**Priority Projects Standing Advisory Committee Report**  
Referral 23: Stewart Street, Richmond  
Yarra Planning Scheme

**5 December 2022**

Referral 23: Stewart Street, Richmond

This is Referral 23. It relates to a proposal for a nine-storey building at 9-13 Stewart Street, Richmond.

**Figure 5 Comparison diagram**

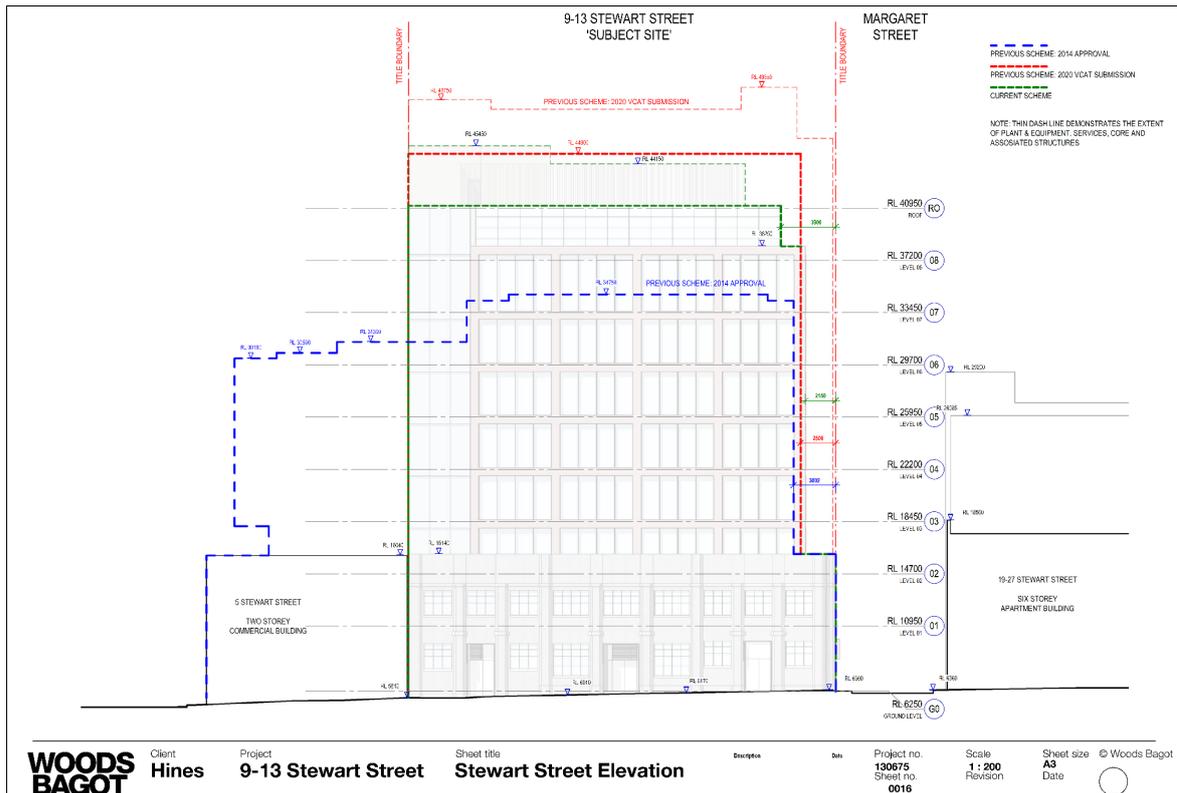
At the Committee's request, the Proponent provided a comparison of the 2014 approved scheme, 2020 VCAT rejected scheme, and the current proposal (Figure 5). Council reviewed the comparison and agreed to the accuracy of the analysis. Measured from the footpath level at the street corner to the top of the plant parapet, the heights are:

- 2014 Approved Scheme 28.4 metres
- 2020 VCAT Rejected Scheme 42.4 metres
- Current Proposal 37.8 metres.

- 1. The building height reduced to below 33 metres, from the ground level to the top of the plant parapet or screen, or any plant equipment with:**
  - the height reduction to be achieved by deletion of typical levels being an anticipated to be a reduction of two levels; and
